# Modifications for PoDL with NGAUTO

GITESH BHAGWAT

# Presentation Outline

# MDI Return Loss

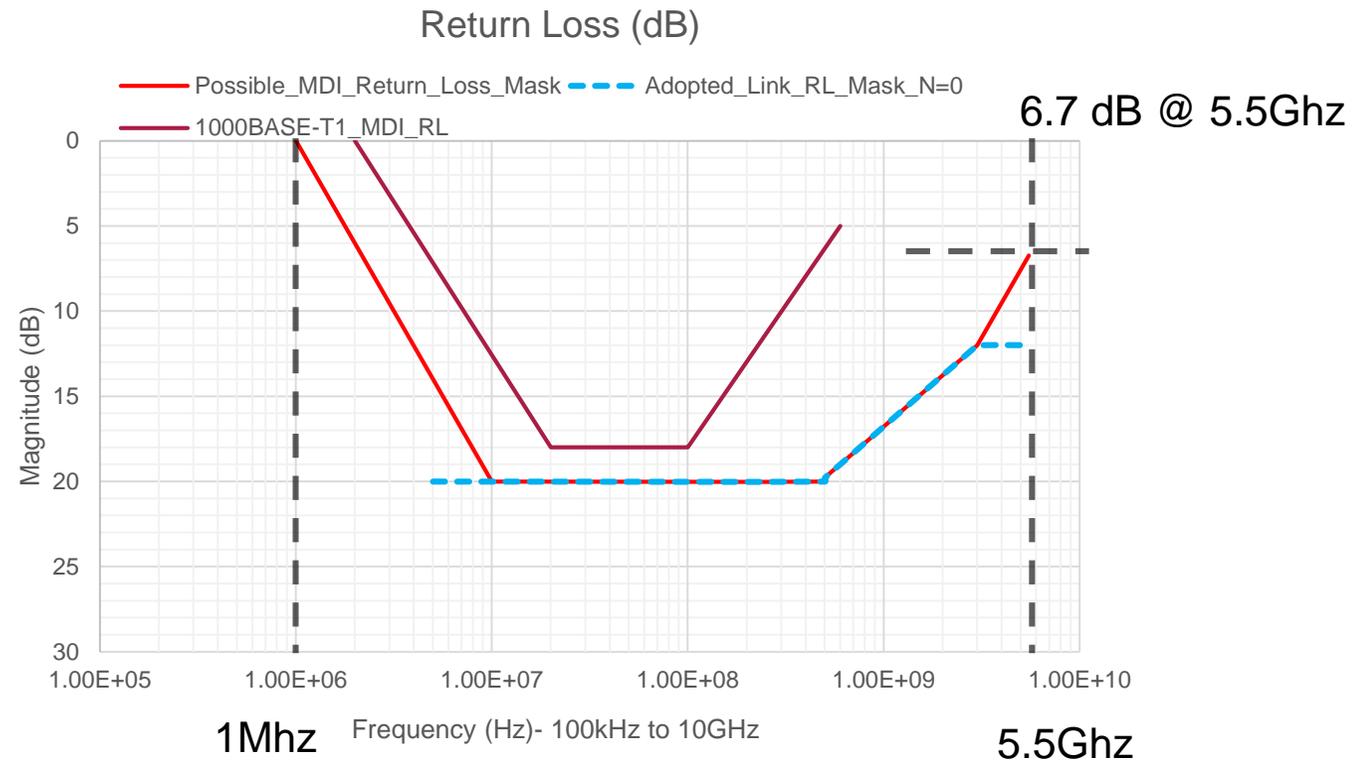
- ▶ References: [bhagwat 3ch 02a 0718.pdf](#) , [bhagwat 3ch 01a 0918.pdf](#) and [DenBesten 3ch 01 1118.pdf](#)
- ▶ 1000BASE-T1 MDI Return Loss shown for reference
- ▶ Low Frequency for NGAUTO extended to 1Mhz

## Return Loss $\geq$

- $20 - 20 \times \text{Log}_{10}\left(\frac{10}{f}\right)$  for  $1 \leq f \leq 10$
- 20 for  $10 \leq f \leq 500$
- $12 - 10 \times \text{Log}_{10}\left(\frac{f}{3000}\right)$  for  $500 \leq f \leq 3000$
- $12 - 20 \times \text{Log}_{10}\left(\frac{f}{3000}\right)$  for  $3000 \leq f \leq 5500$

where  $f$  is frequency in MHz
